Addendum No. 1

Subject: Alexander Adaire Elementary School – Mechanical Plant Replacement
SDP Contract No. B-119C, B-120C, B-121C of 2016/17

This Addendum, dated May 4, 2018, shall modify and become part of the Contract Documents for the work of this project. Any items not mentioned herein, or affected by, shall be performed strictly in accordance with the original documents.

CHIMNEY OPENING DETAIL

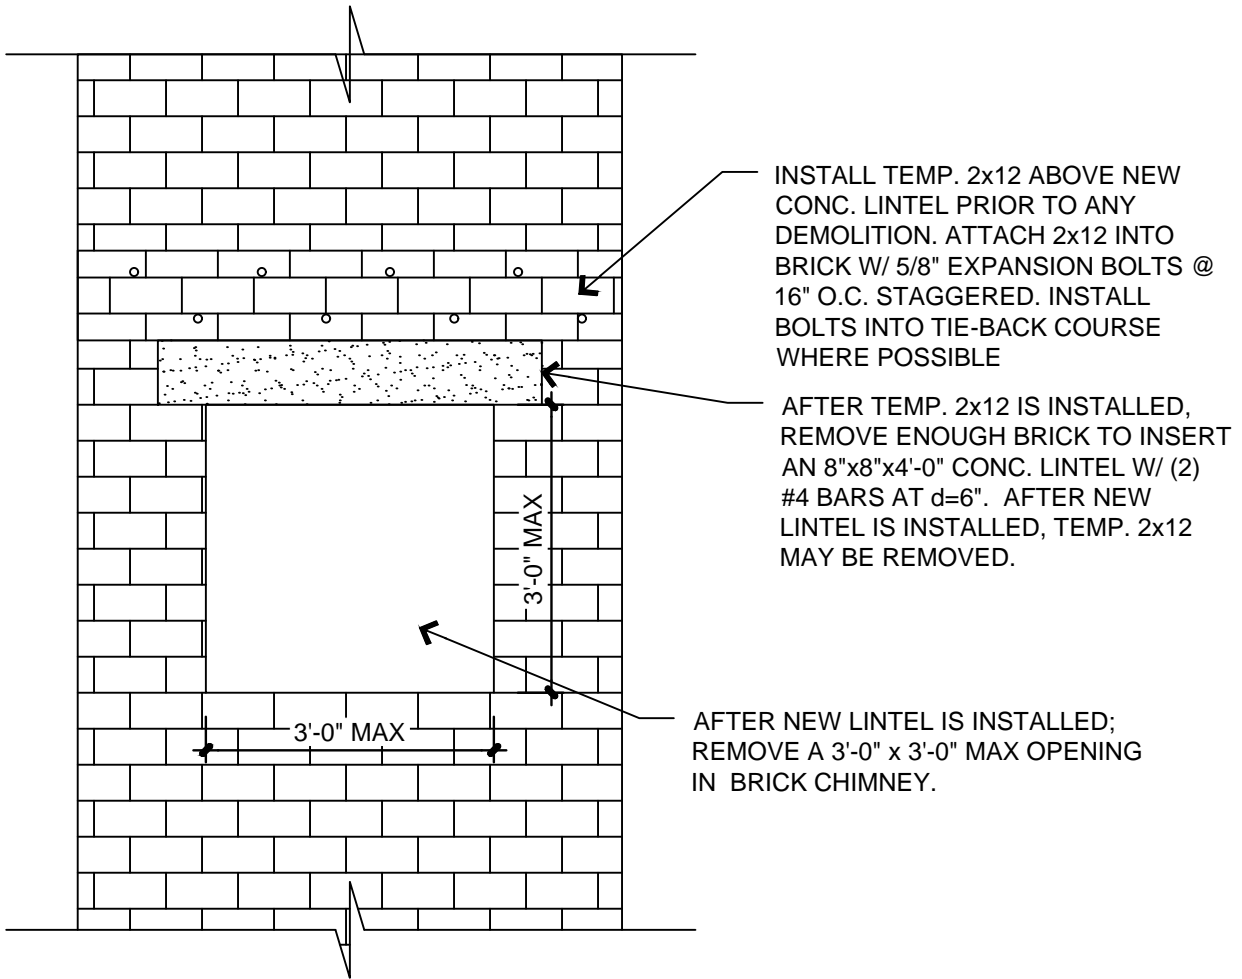
1. Drawing S2.0 – Chimney Opening Detail: Add Detail F4 as shown on attached Drawing SK-1.
2. Drawing M0.0 – General Notes: Delete General Note 15.
3. Drawing M0.0 – Mechanical Abbreviations and Symbols Legend: Add the following:

LOCATION: GENERAL CONTRACTOR SHALL PROVIDE OPENING IN EXISTING CHIMNEY ON THE SECOND FLOOR (CORRIDOR SIDE).

RESTORATION: AFTER NEW BOILER BREECHING IS COMPLETED BY THE MECHANICAL CONTRACTOR, THE GENERAL CONTRACTOR SHALL PROVIDE MASONRY INFILL OF THE OPENING. MASONRY INFILL SHALL MATCH FULL WALL DEPTH OF EXISTING CHIMNEY. FINISHED SURFACE SHALL BE FLUSH WITH ADJACENT WALL AND PAINTED TO MATCH THE EXISTING ADJACENT WALL.

NOTE: CHIMNEY WORK SHALL NOT BEGIN UNTIL EXISTING BOILERS ARE PERMANENTLY REMOVED FROM SERVICE.
